<b>AMENDMENT OF SOLICITATION/MODIFICATION OF CONTRACT</b>				1. CONTRACT ID CODE <div style="text-align: center;">J</div>		PAGE OF PAGES <div style="text-align: center;">1   3</div>

14. DESCRIPTION OF AMENDMENT/MODIFICATION (Organized by UCF section headings, including solicitation/contract subject matter where feasible.) The purpose of Amendment 0006 is to clarify contractor questions, "Geothermal Wellfields, revitalize Barracks USMA Preparatory School Building 1204 & 1205, Fort Monmouth, Eatontown, NewJersey."  NOTE: Bidders must acknowledge receipt of this amendment by the date specified in the solicitation (or as amended) by one of the following methods: In the space provided on the SF 1442, by separate letter, or by telegram, or by signing Block 15 below. FAILURE TO ACKNOWLEDGE AMENDMENTS BY THE TIME SPECIFIED MAY RESULT IN REJECTION OF YOUR BID IN ACCORDANCE WITH THE LATE BID, LATE MODIFICATIONS OF BIDS OR LATE WITHDRAWAL OF BIDS (FAR 14.304).  The Bid Opening Date remains unchanged, 25 June 2002.							
<small>Except as provided herein, all terms and conditions of the document referenced in Item 9A or 10A, as heretofore changed, remains unchanged and in full force and effec

Specification 15741 section 3.4

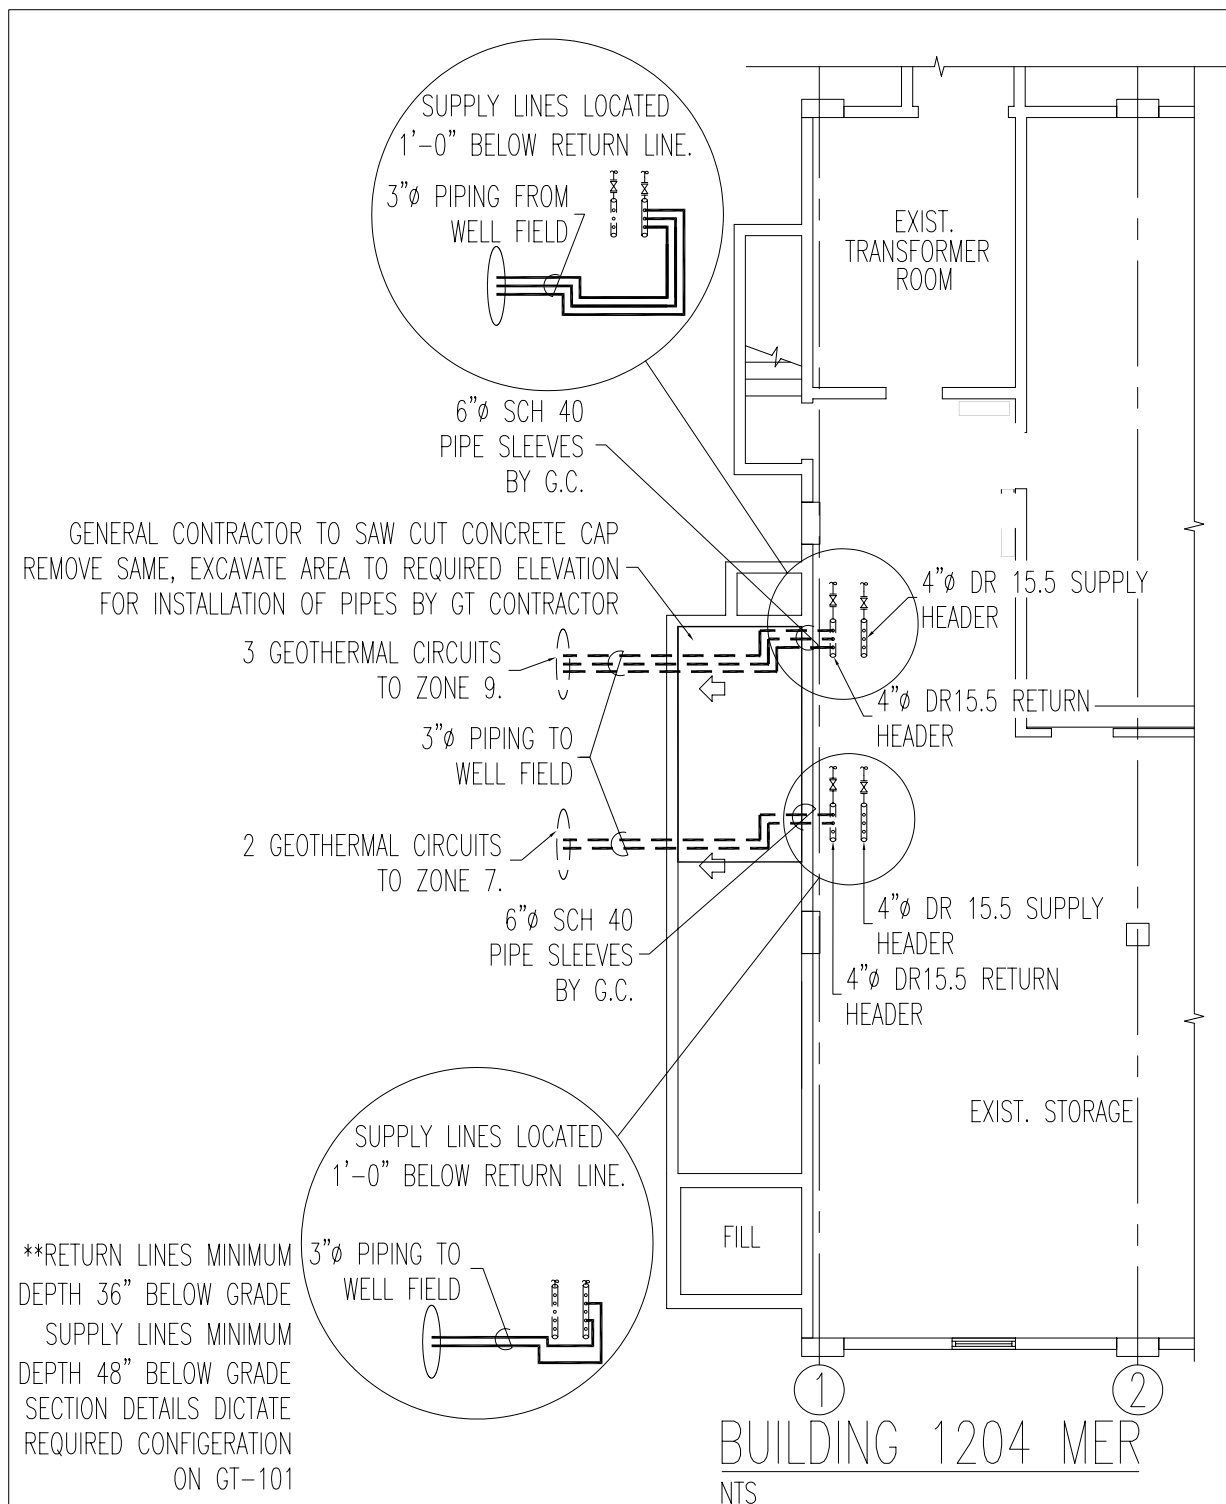
Add the following paragraph after paragraph (a)

Where two GT pipes (S&R) are required serving a common well system, it is acceptable for both pipes to be installed 48" below grade in lieu of the supply being installed 48" below grade and the return being installed 36" below grade. It is preferable that GT pipes be installed 48" below grade but this detail may impact excavated trench width. No extras will be considered if GT contractor opts to lay all pipes at 48" below grade for expedient excavation looping and back filling reasons.

TYPICAL PLAN VIEW FOR ALL FIRST FLOOR TOWER MER ROOMS

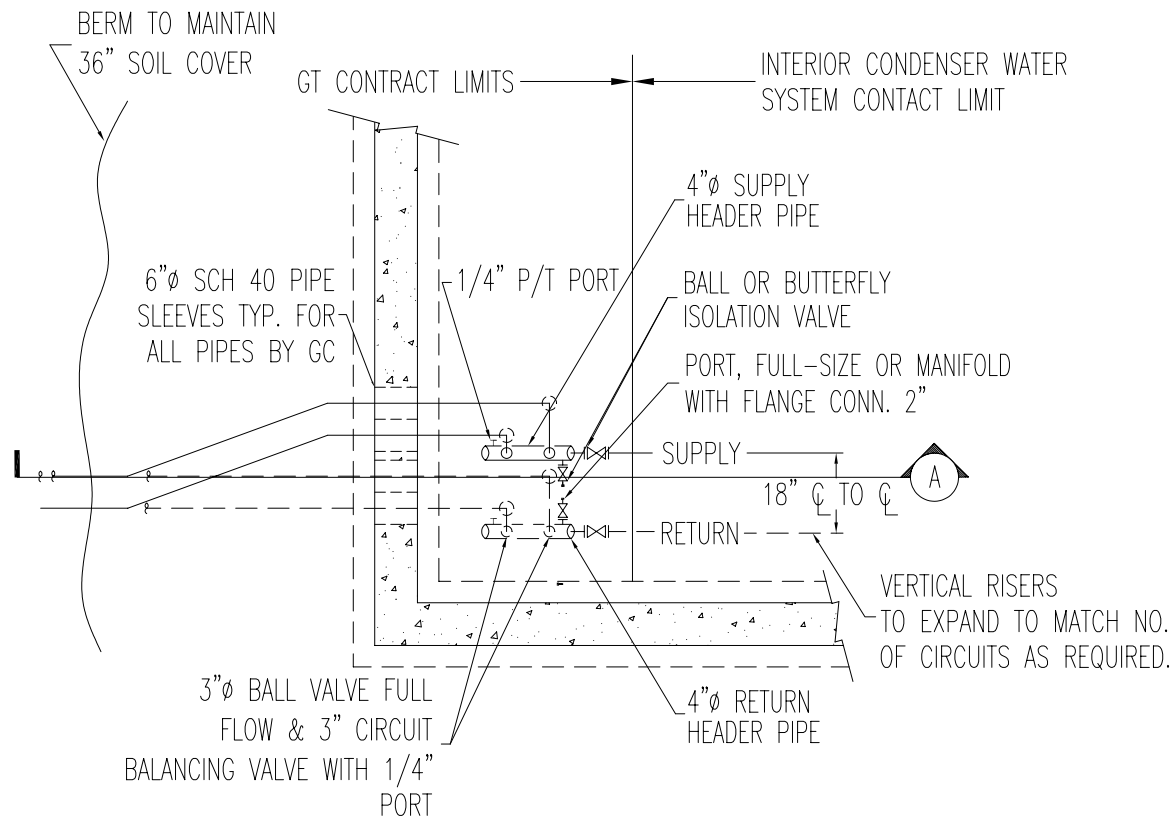
Attached (SK-1, SK-2 and SK-3) three sketches for coordination of GT piping entering building with the Barracks General Contractor.

MER 113, BUILDING 1204 - 1 SET-3"Ø S & R CIRCUITS  
 MER 114, BUILDING 1204 - 1 SET-3"Ø S & R CIRCUITS  
 MER 112, BUILDING 1205 - 1 SET-3"Ø S & R CIRCUITS  
 MER 114, BUILDING 1205 - 1 SET-3"Ø S & R CIRCUITS  
 MER 123, BUILDING 1205 - 2 SET-3"Ø S & R CIRCUITS  
 MER 126, BUILDING 1205 - 2 SET-3"Ø S & R CIRCUITS  
 MAIN MER BUILDING 1204 - 5 SET-3"Ø S & R CIRCUITS

GT CONTRACTOR TO CO-ORDINATE WORK WITH GENERAL CONTRACTOR
